STATE OF HAWAII
DEPARTMENT OF TRANSPORTATION
HIGHWAYS DIVISION
UTILITY PLAN
MAUNA KEA MAINTENANCE
BASEYARD
DANIEL K. INOUE HIGHWAY
Project No. 200A-01-10
Scale: As Shown Date: April, 2018

1	06-07-18	ADDENDUM NO. 4	
REVISION	DATE	DESCRIPTION	AA15

STATE OF HAWAII
DEPARTMENT OF TRANSPORTATION
HIGHWAYS DIVISION
SHOP BUILDING
MAUNA KEA MAINTENANCE BASEYARD
DANIEL K. INOUE HIGHWAY
Project No. 200A-01-10

AA22

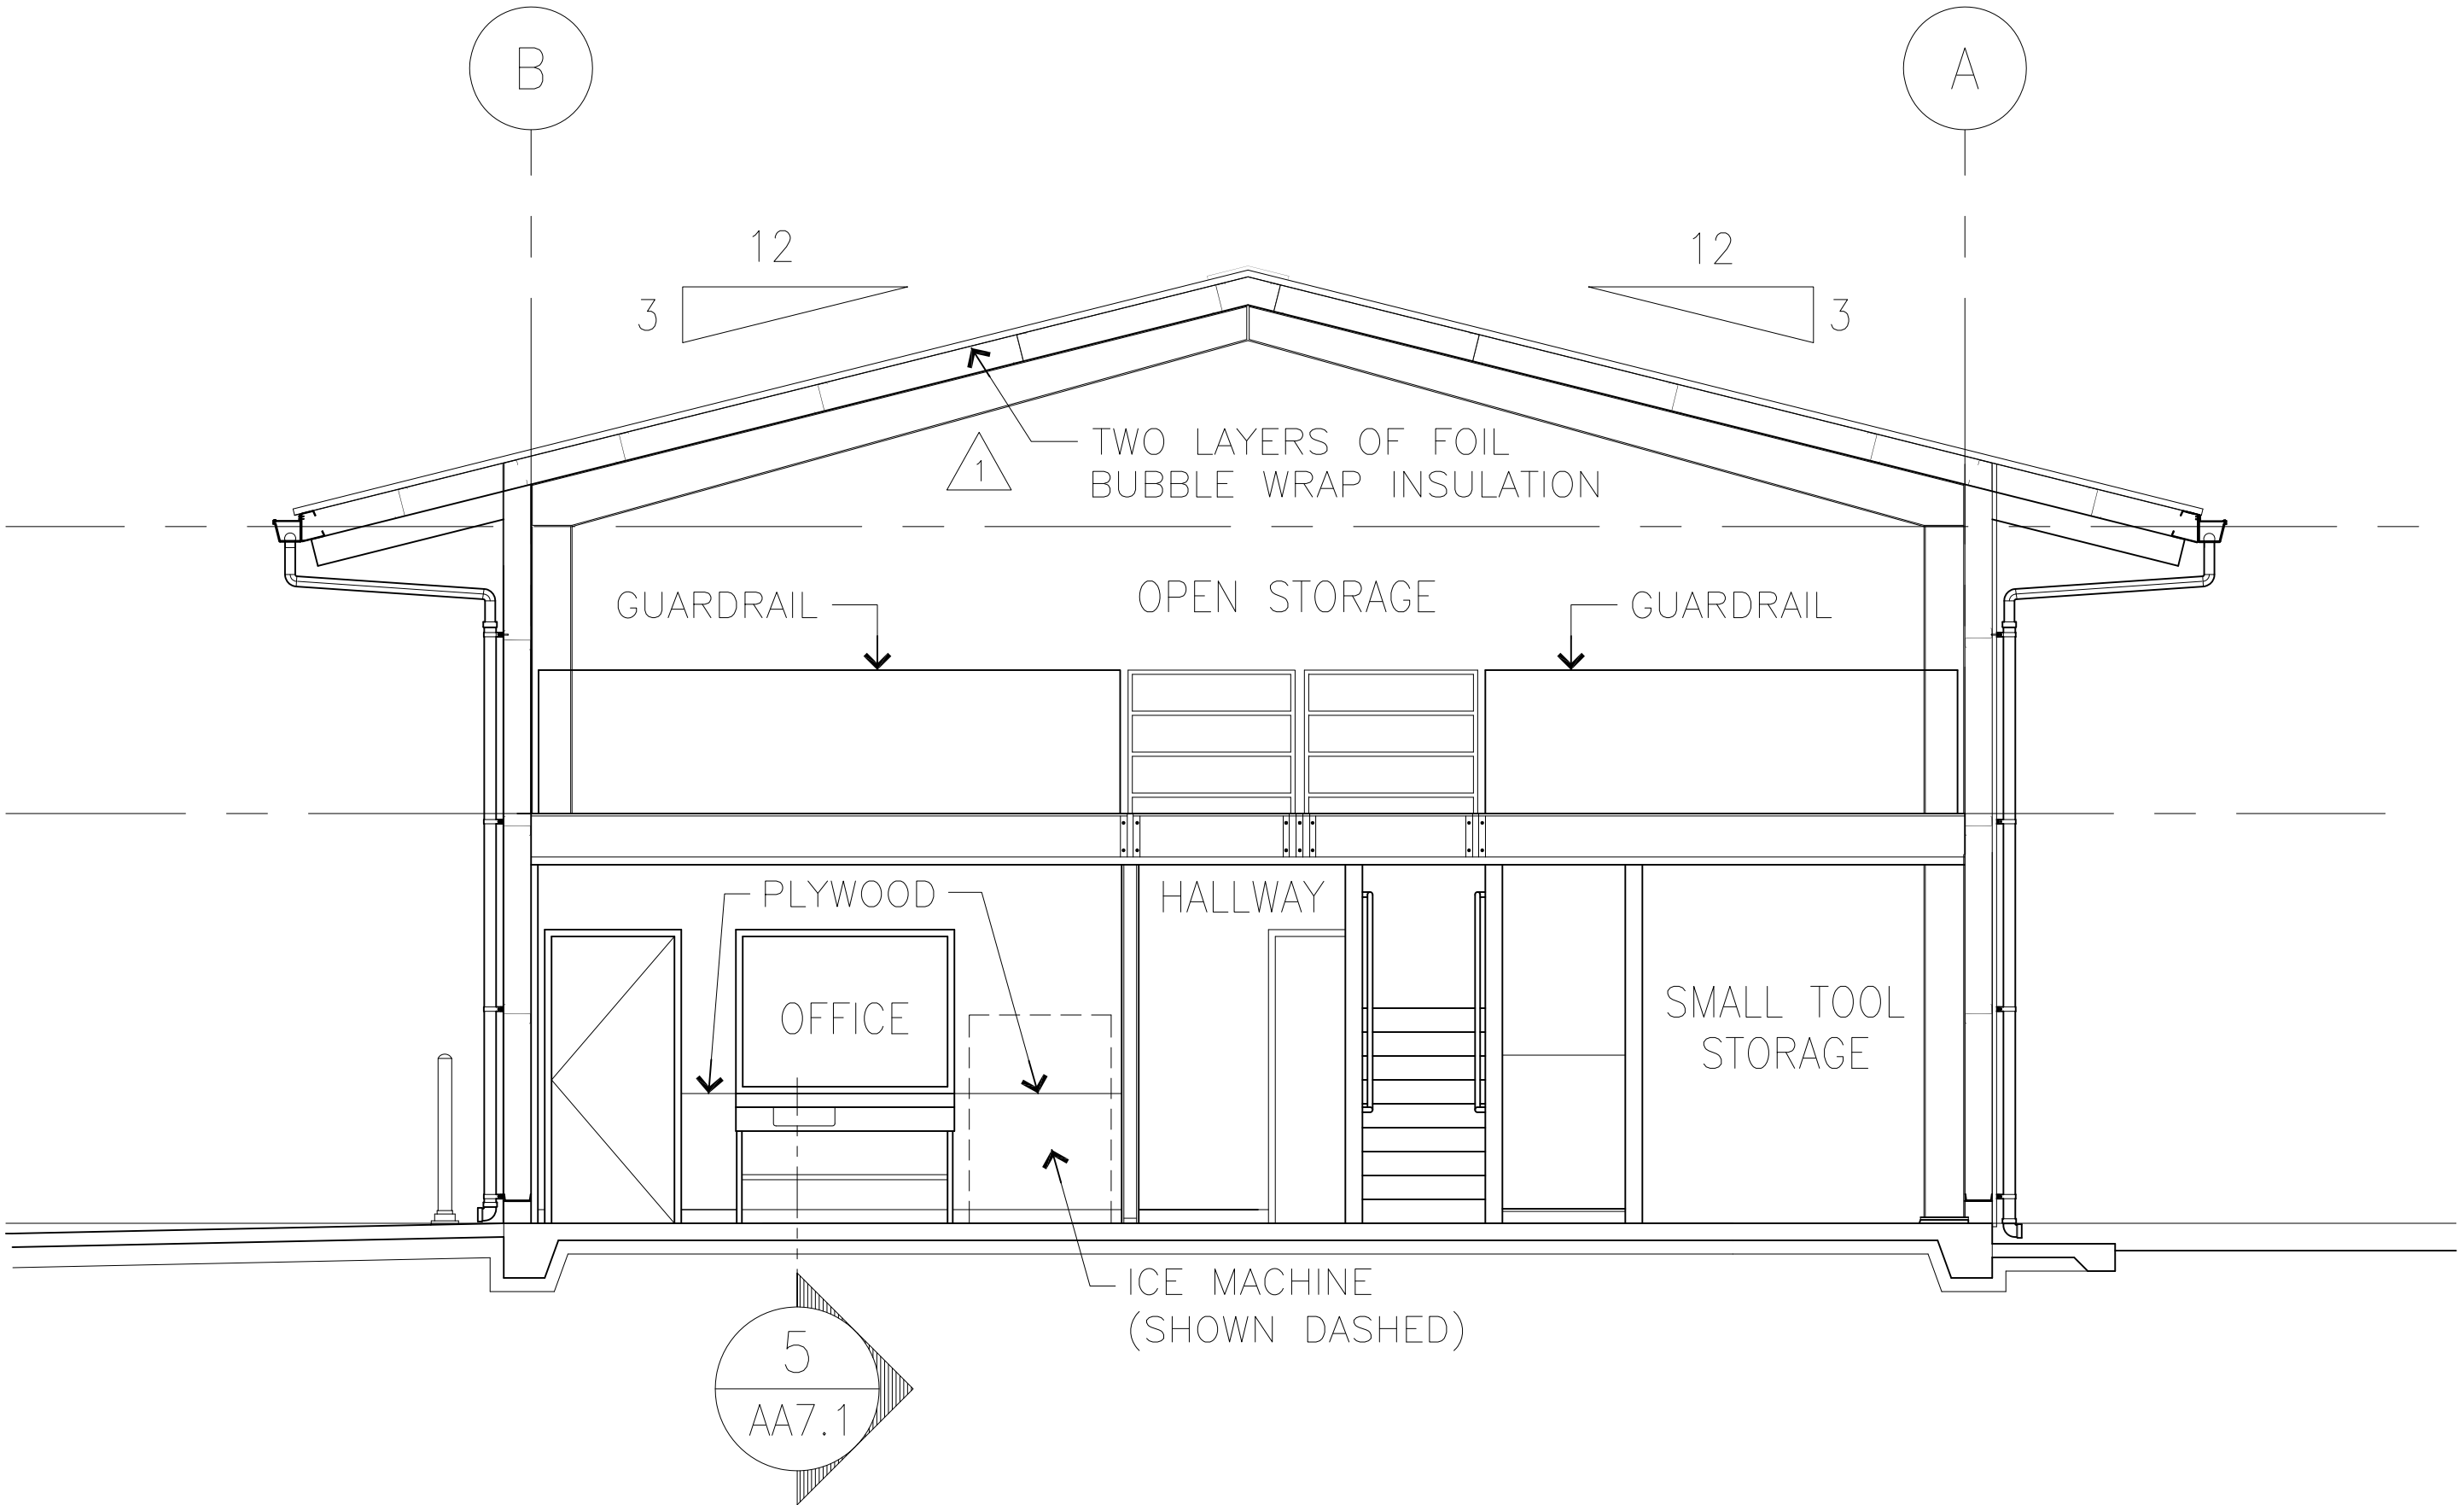
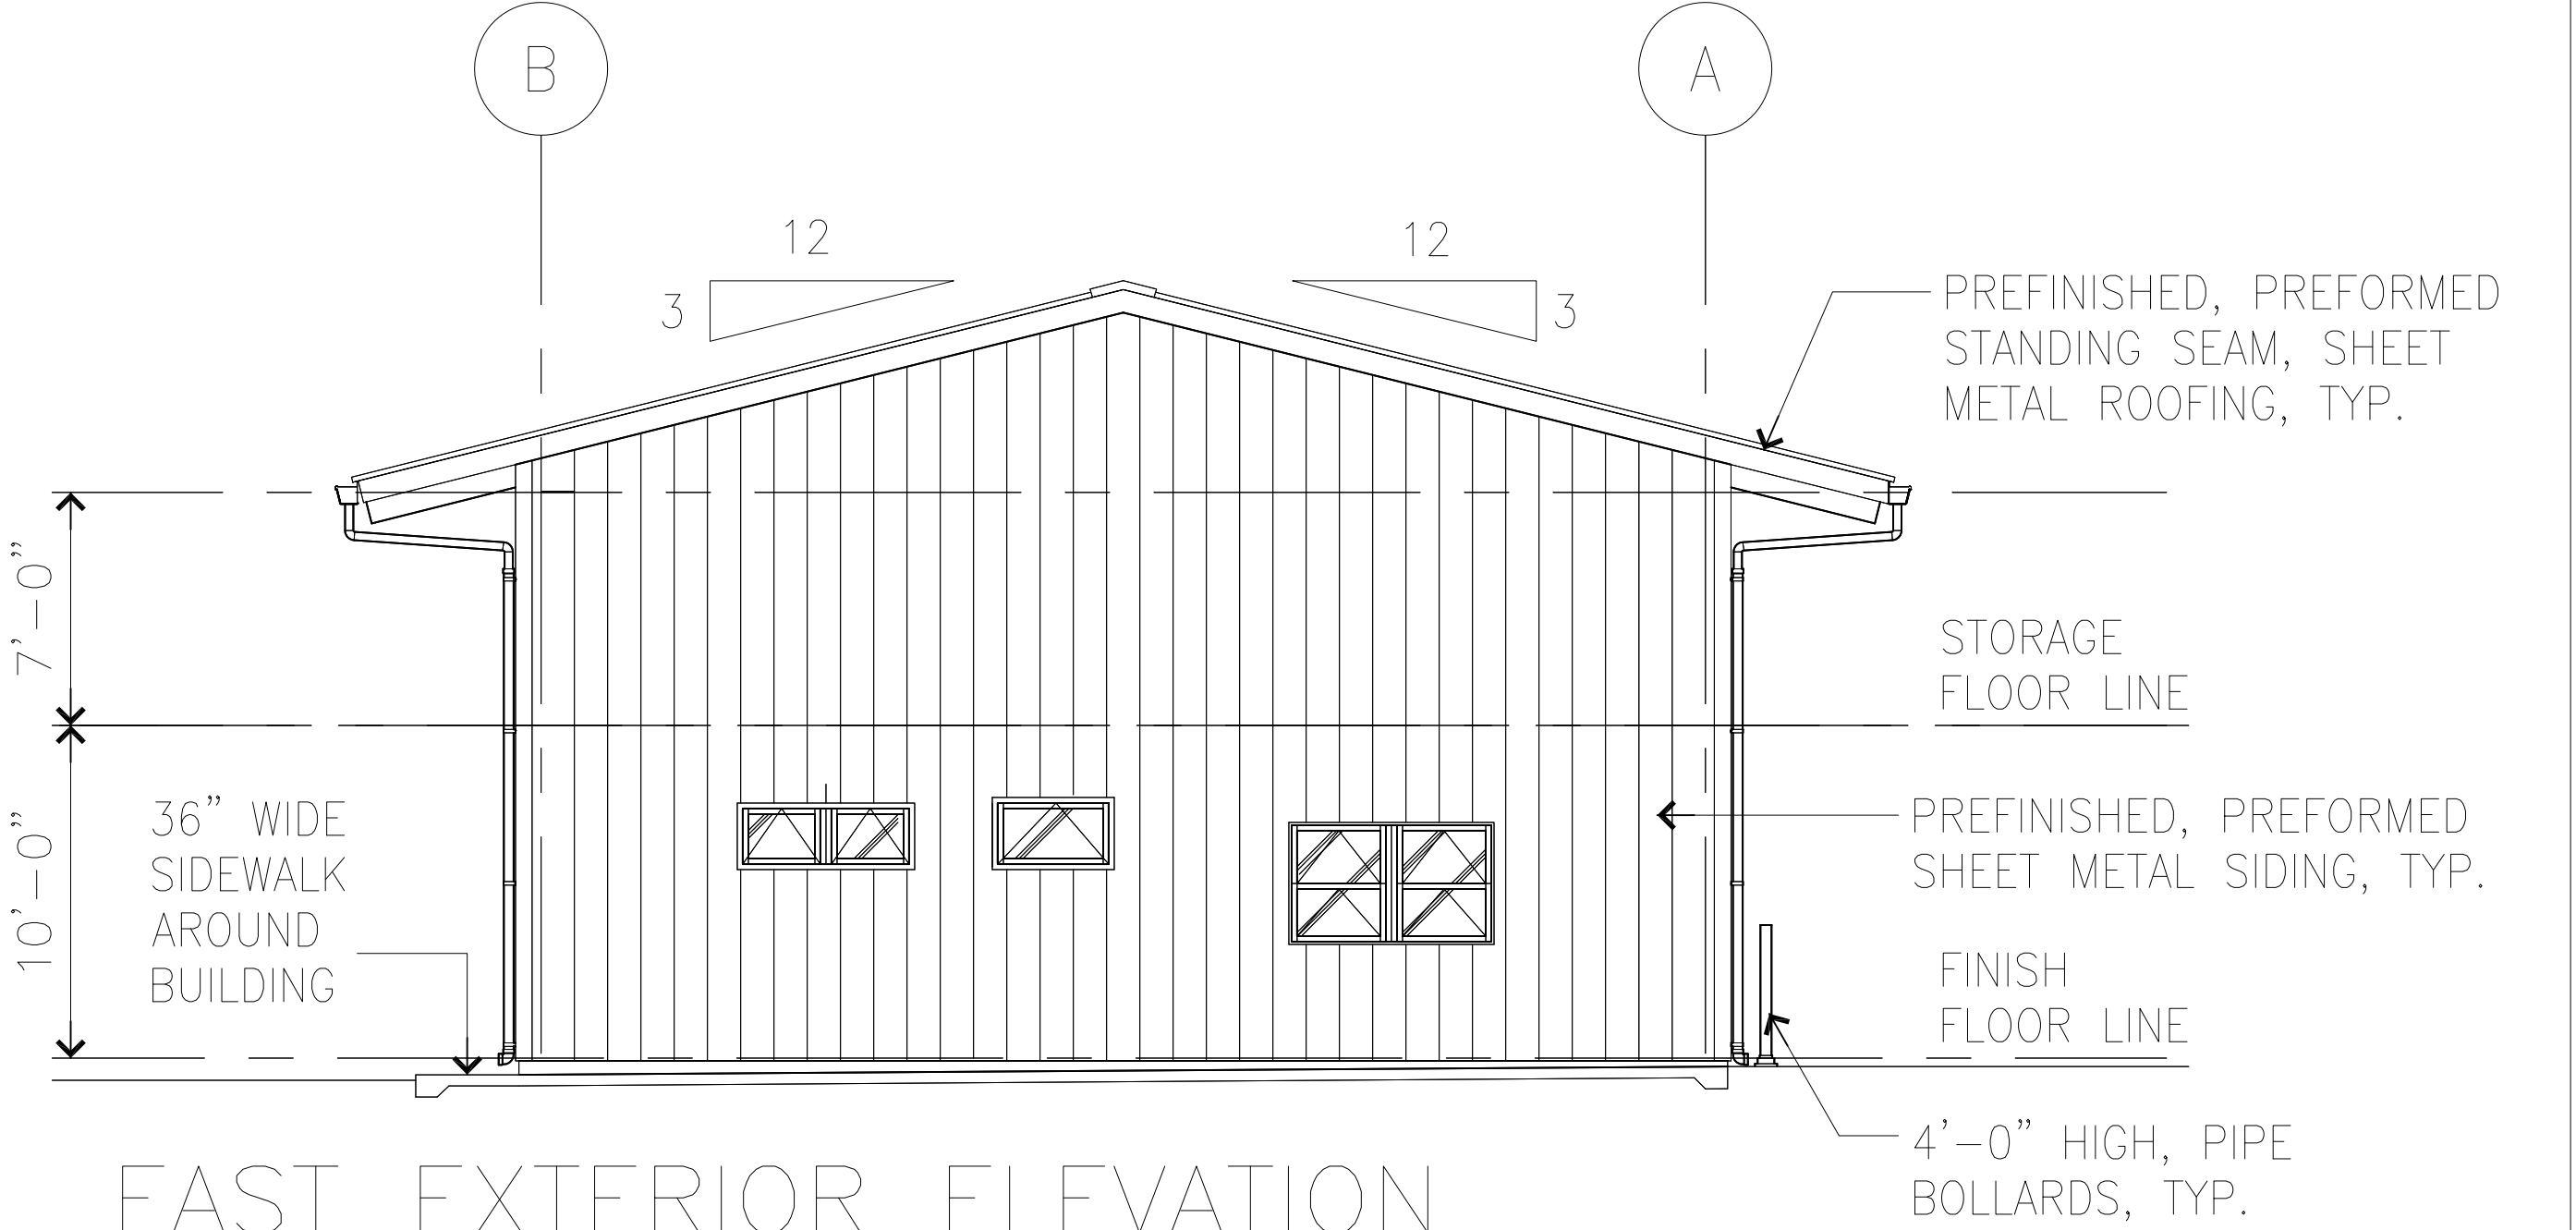
06-07-18	1	REVISED DIMENSION AND INSULATION LOCATION
DATE	REVISION
